Red Clay Consolidated School District
AI DuPont Middle School HVAC Renovations
Bid Pac "A"

ADDENDUM #1 ISSUED BY EDiS COMPANY
110 S. POPLAR STREET, WILMINGTON, DE 19801

1 / 3.16 ROOF PLAN

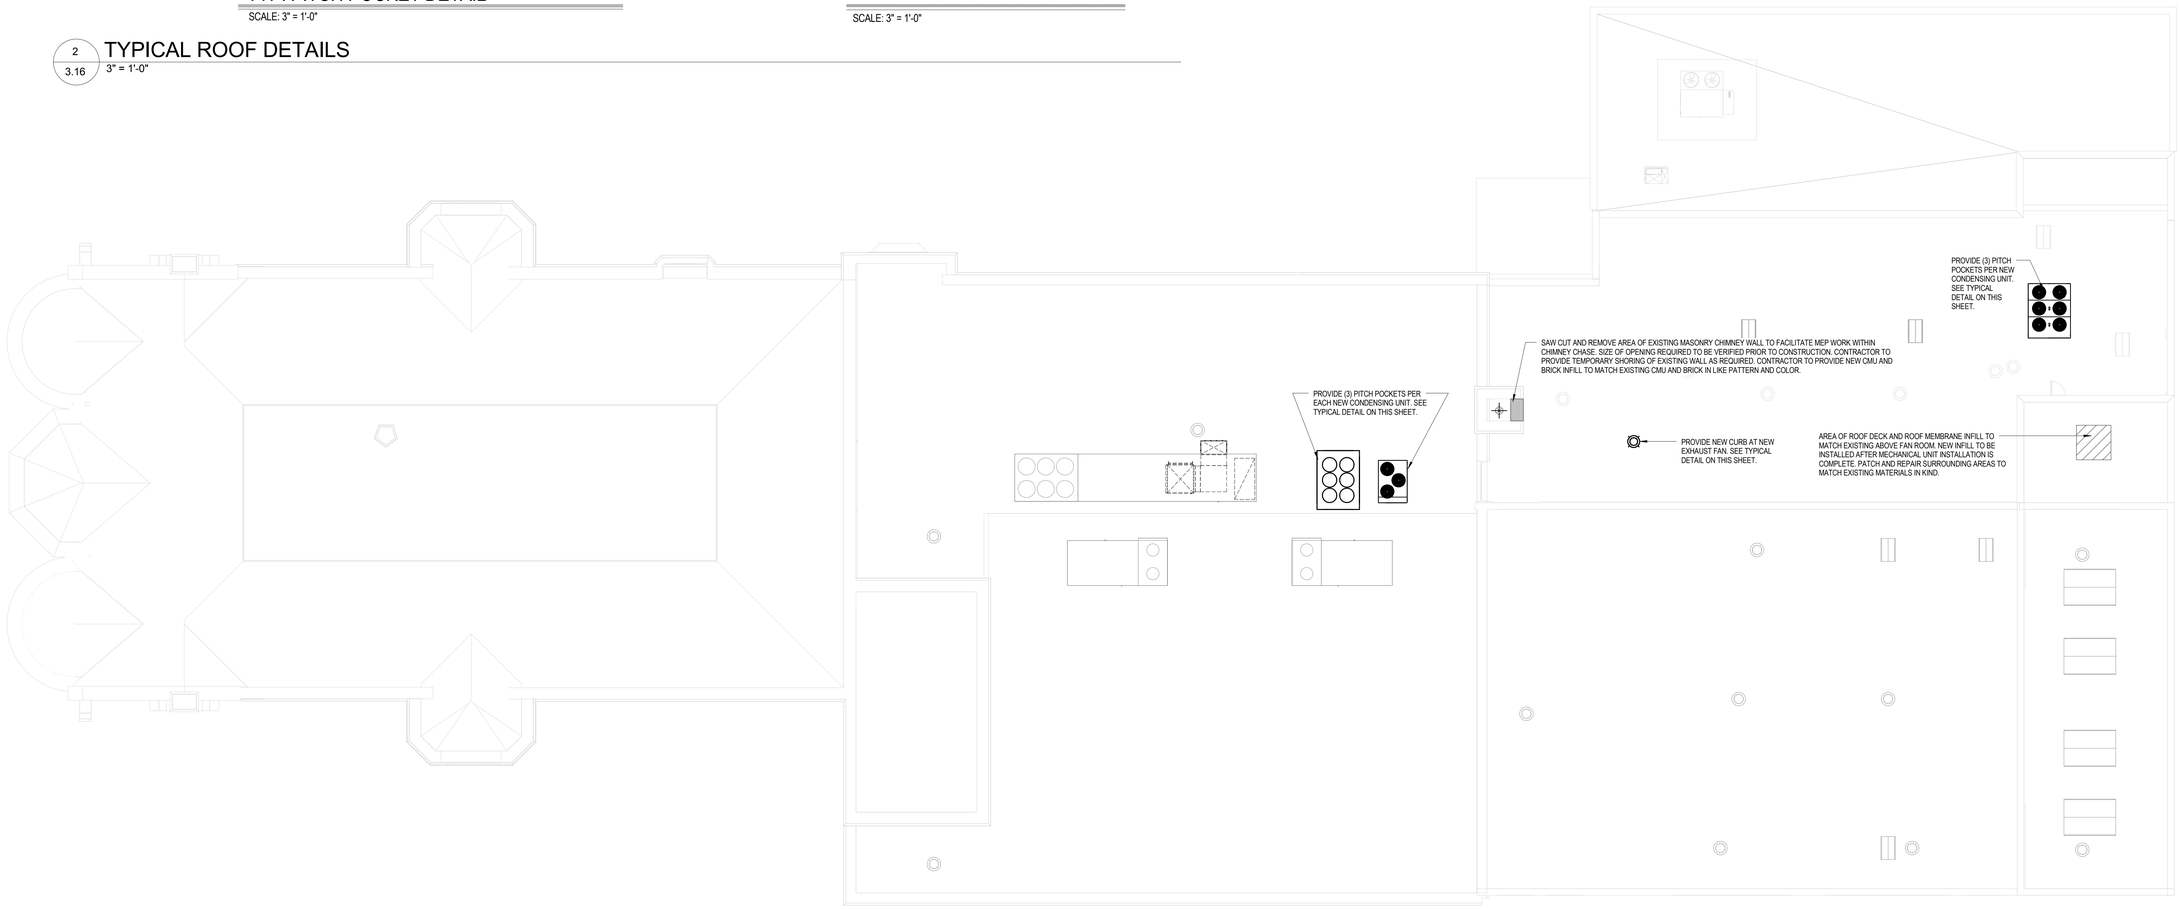
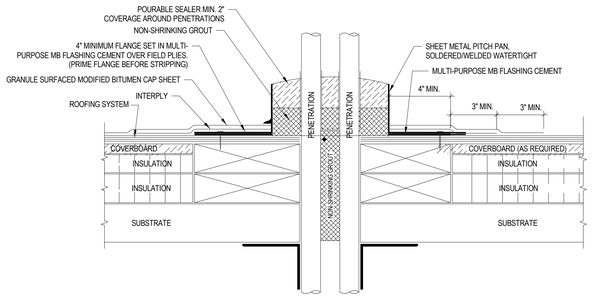
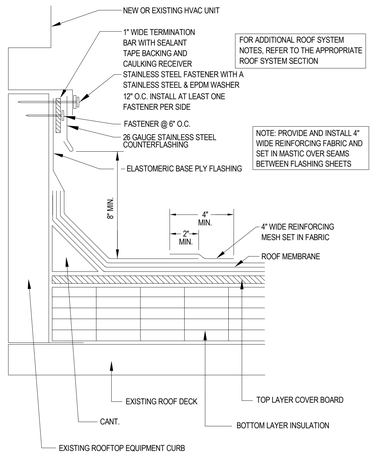
1. Add the following drawing (attached): A3.16 – Roof Plan and Details
2. Drawing A3.4 – Keynote #4 revised to read, "New ADA platform lift by owner." No sketch issued to reflect this change.

PARTIAL FIRST FLOOR DEMOLITION PLAN - AREA B - 1/A2.4

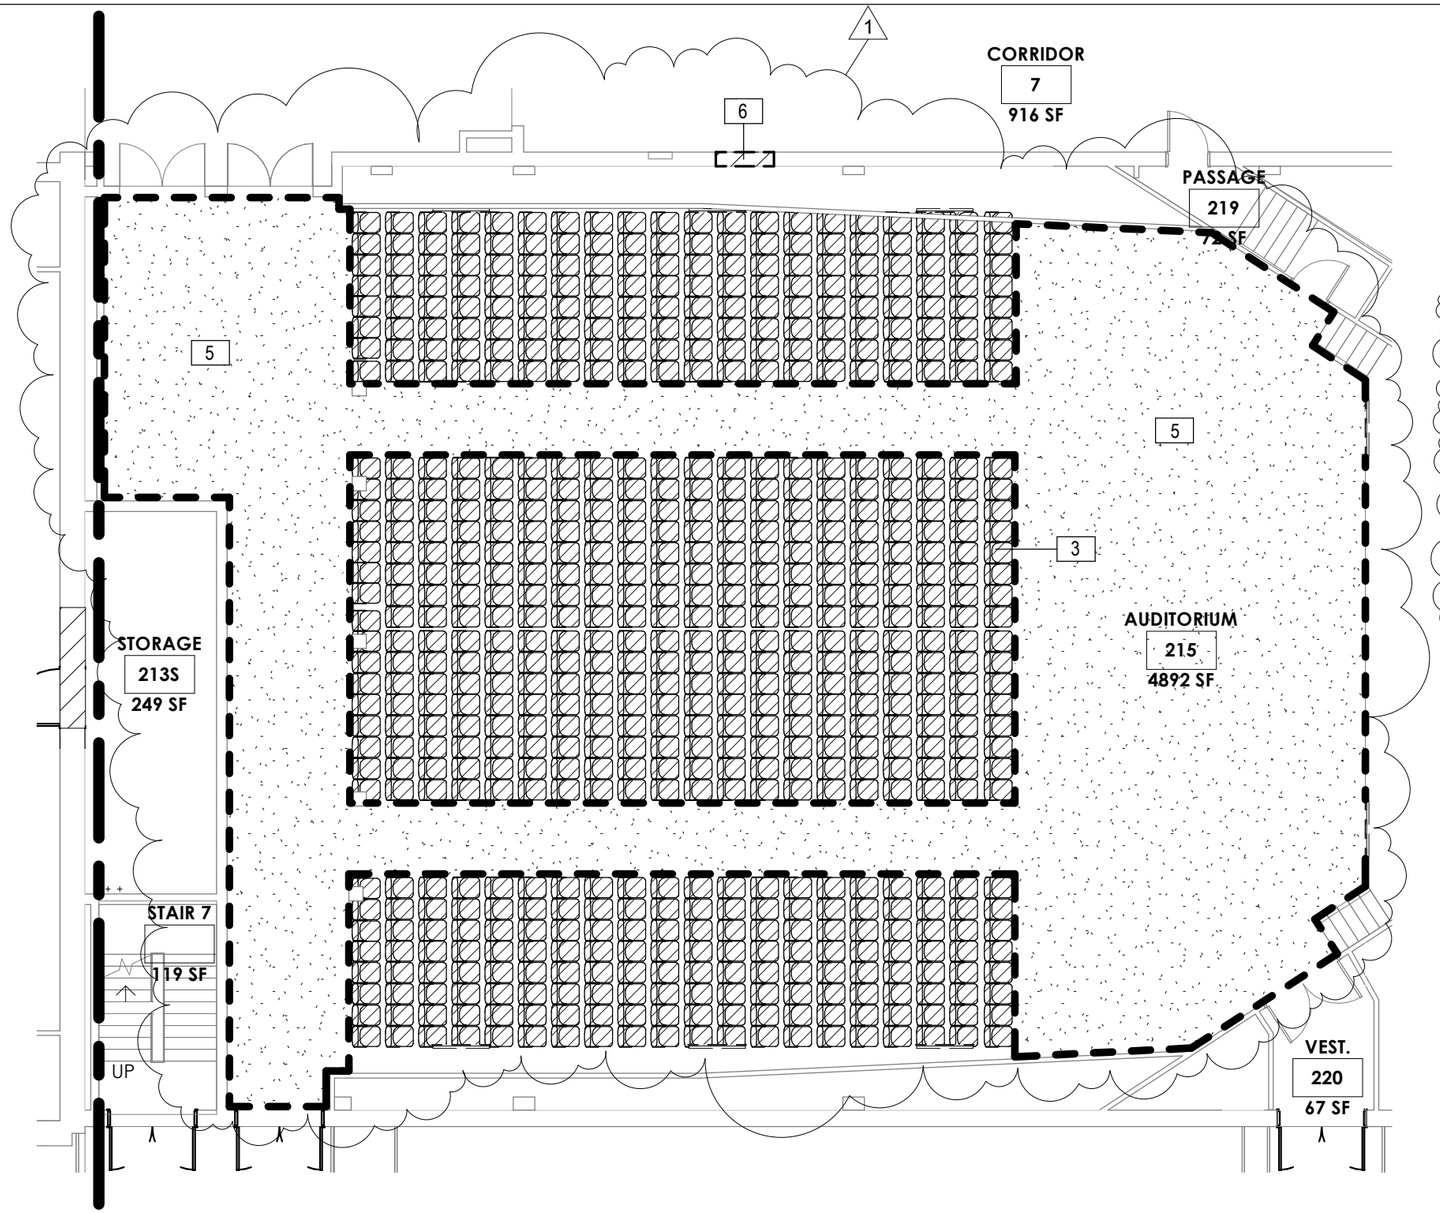
3. Drawing A2.4 – Add demolition of existing floor carpet in Auditorium and partial demolition of existing partition for new electrical panel. See sketch SK-A.1.

PARTIAL 2ND FLOOR DEMO PLAN - AREA B - 1/A2.6

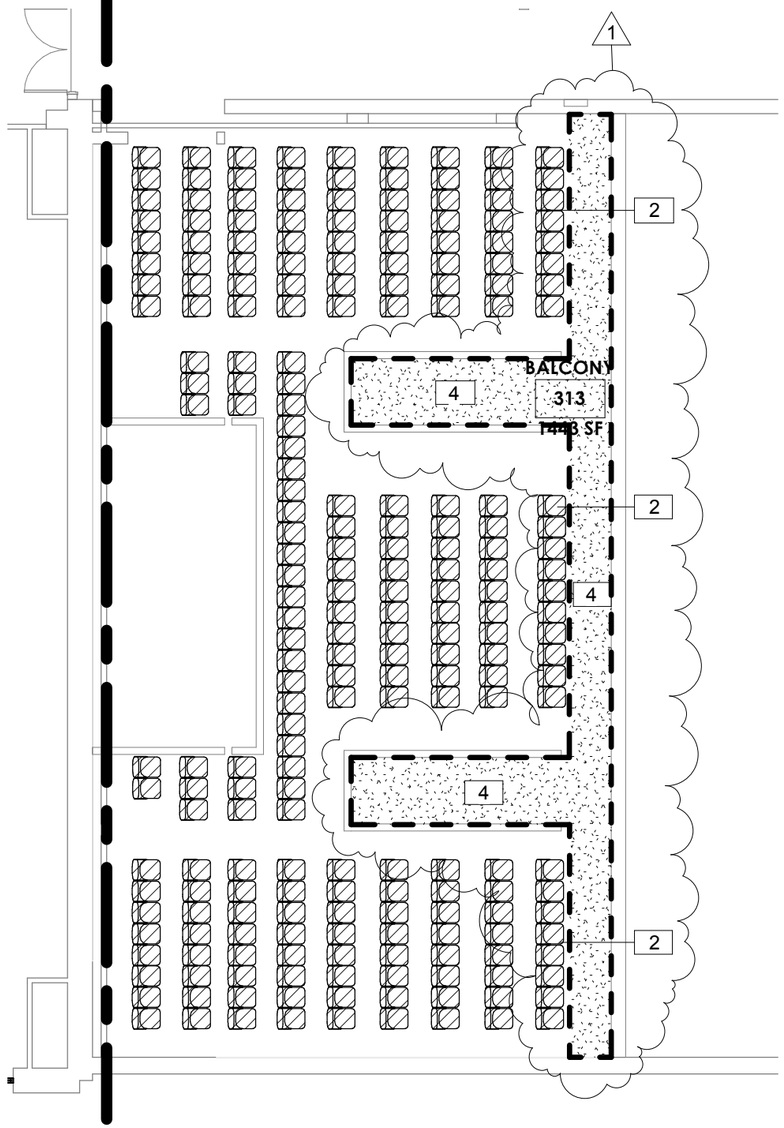
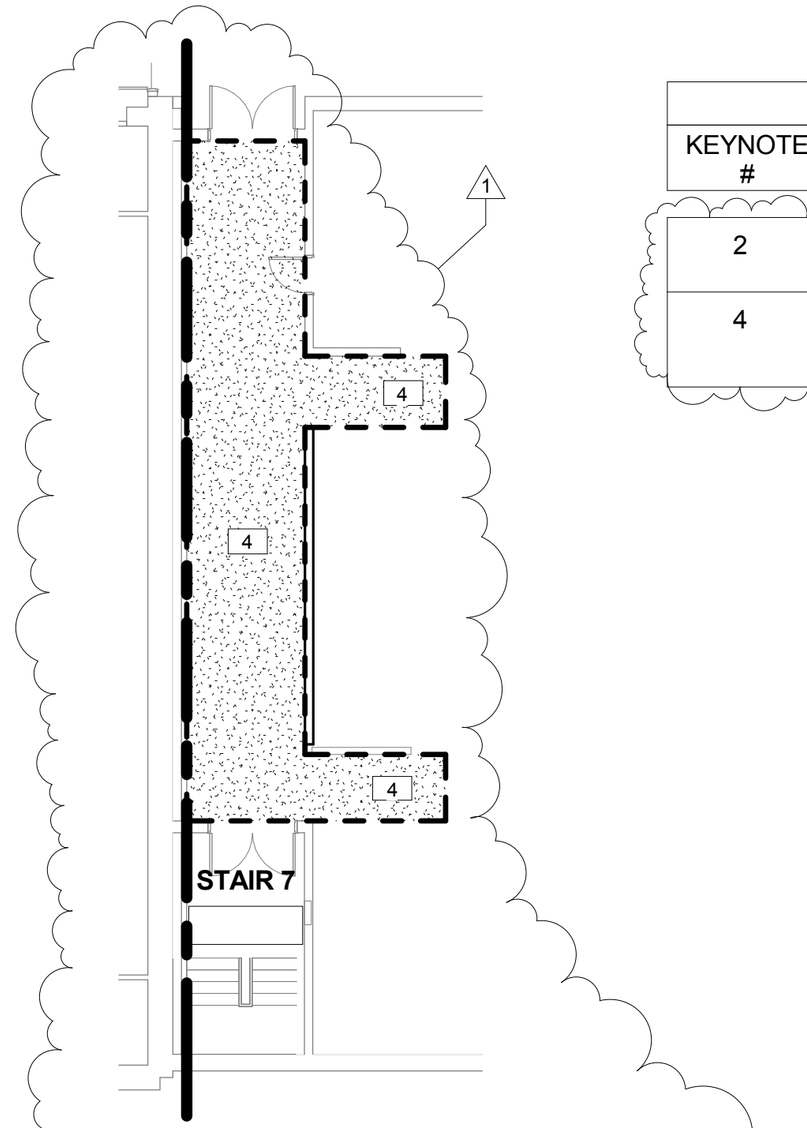
4. Drawing A2.6 - Add demolition of existing floor carpet in Auditorium Balcony level. See sketch SK-A.2.
5. Drawing A2.1 – At Boiler Room, remove existing louver, patch and repair floor at housekeeping pad demolition, and width of trench to be determined by contractor. See sketch SK-A.3.

PARTIAL SECOND FLOOR RCP DEMOLITION PLAN - AREA A - 1/A2.11

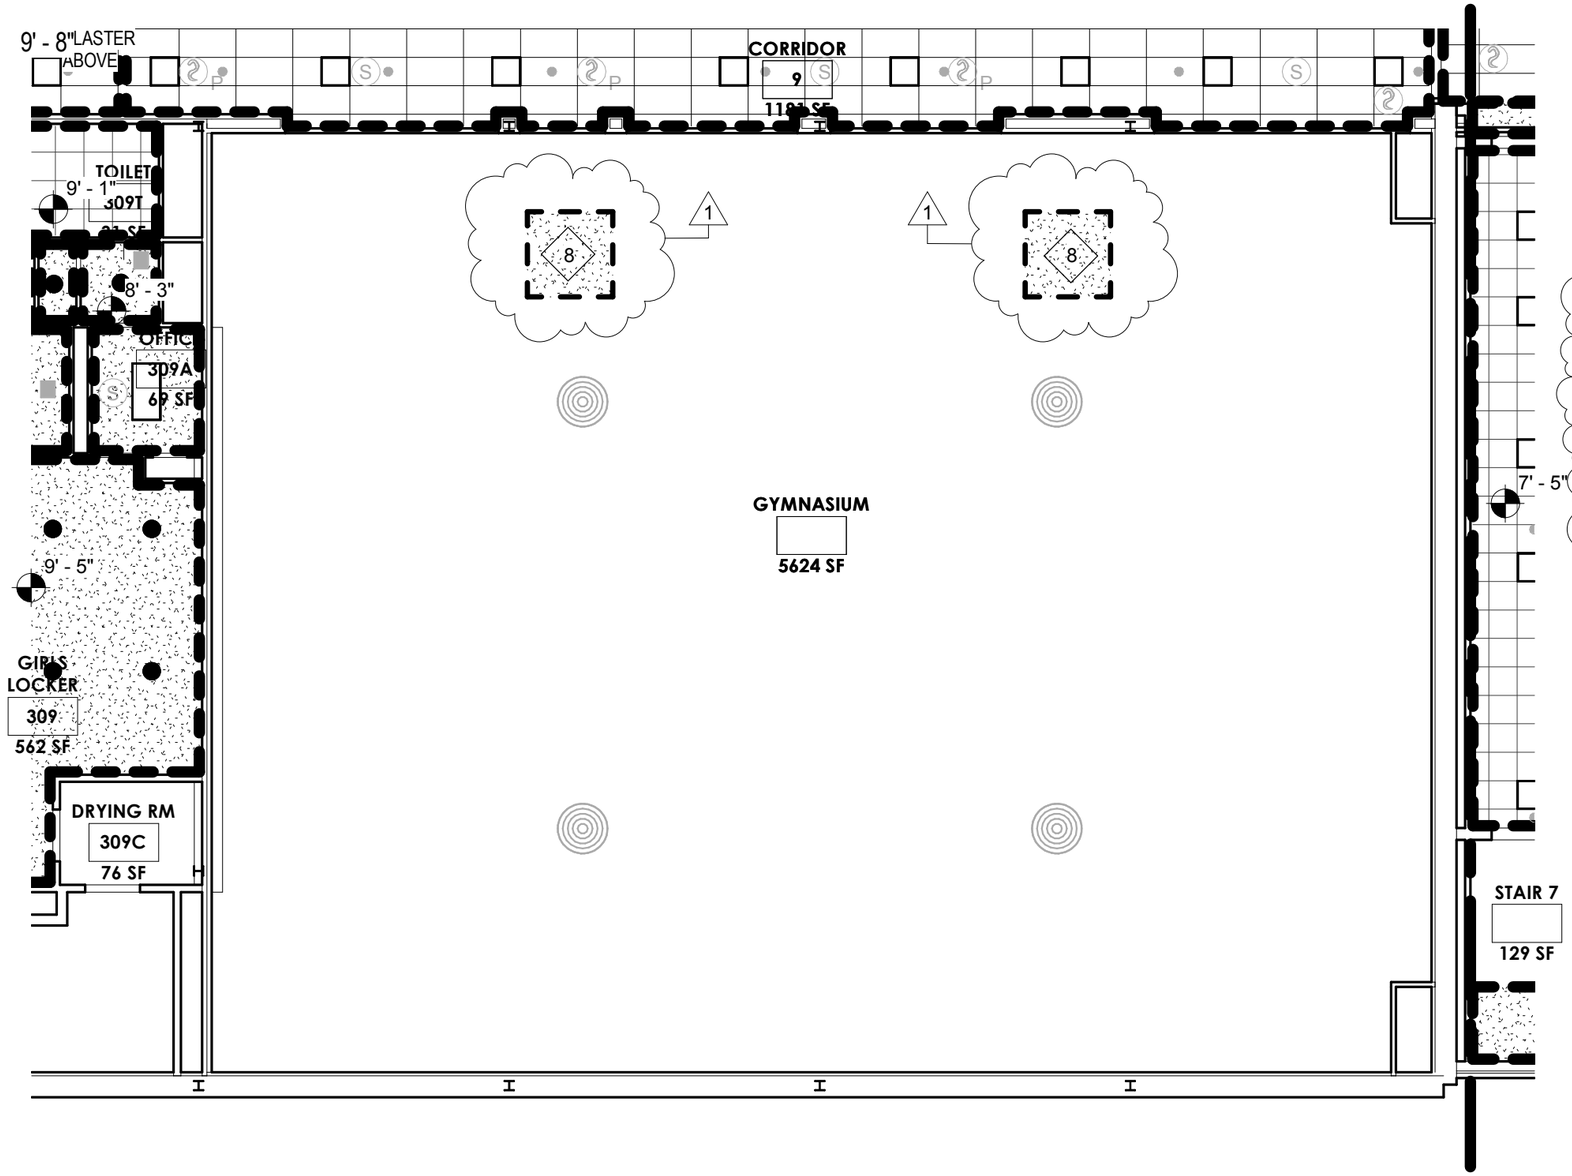
6. Drawing A2.11 – Provide demolition of Gymnasium ceiling at areas of mechanical unit demolition and installation. See sketch SK-A.4.
7. Drawing A2.12 – Revision to note provided to exclude structure in demolition. See sketch SK-A.5.

PARTIAL FIRST FLOOR RCP - AREA A - 1/A3.9

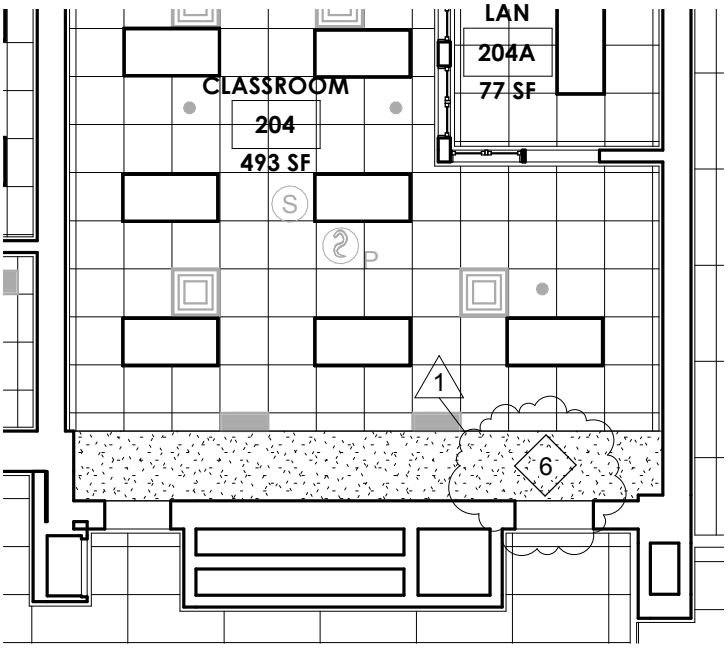
8. Drawings A3.1-A3.6 – Revision to wall infill hatch legend note. See sketch SK-A.6.
9. Drawing A3.9 – Provide new gypsum soffit where existing is to be demolished. See sketch SK-A.7.

PARTIAL LOWER LEVEL DEMO PLAN - AREA A - 1/A2.1

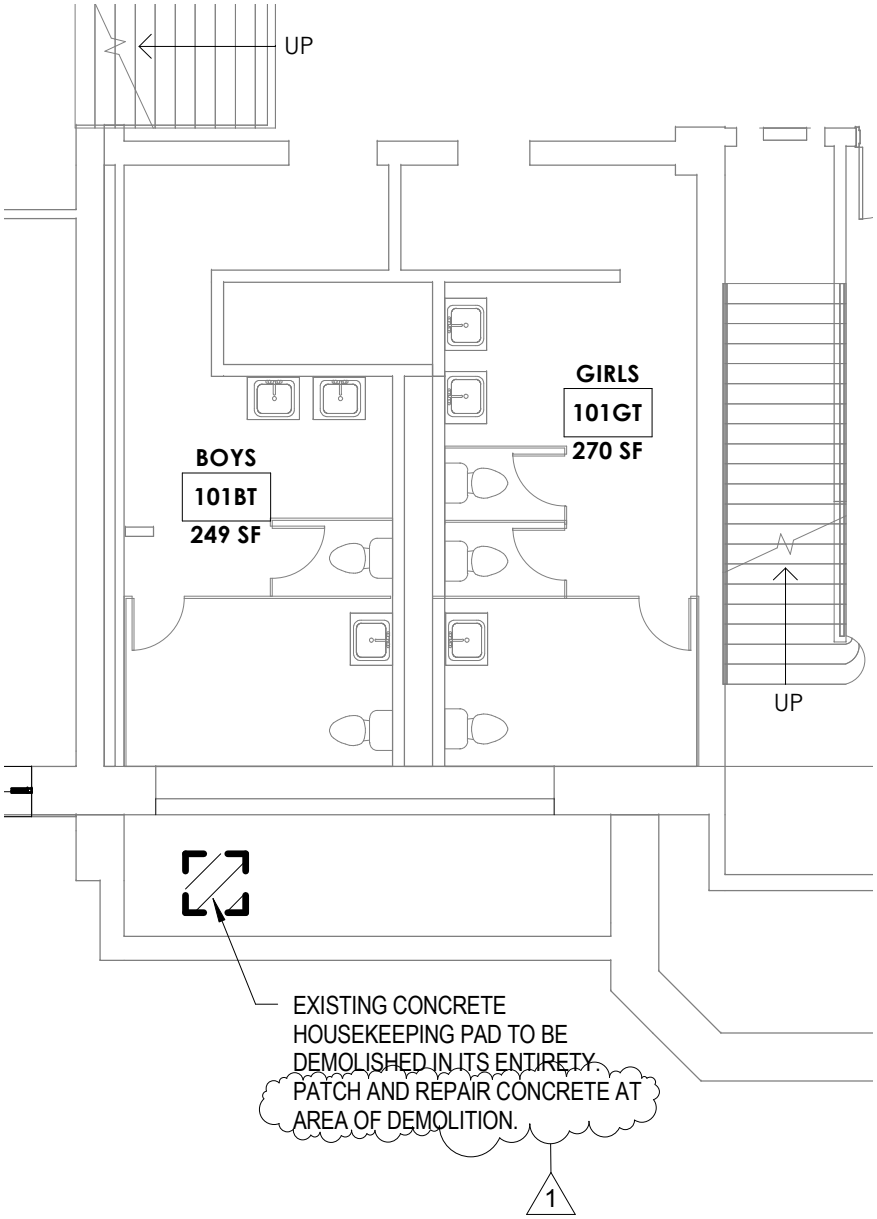
10. Drawing A2.1 – Patch and repair existing concrete at area of existing housekeeping pad demolition. See sketch SK-A.8.
11. Drawing A3.11 - Provide new ceiling patch, repair and paint in Gymnasium at areas of mechanical unit demolition and installation. See sketch SK-A.9.
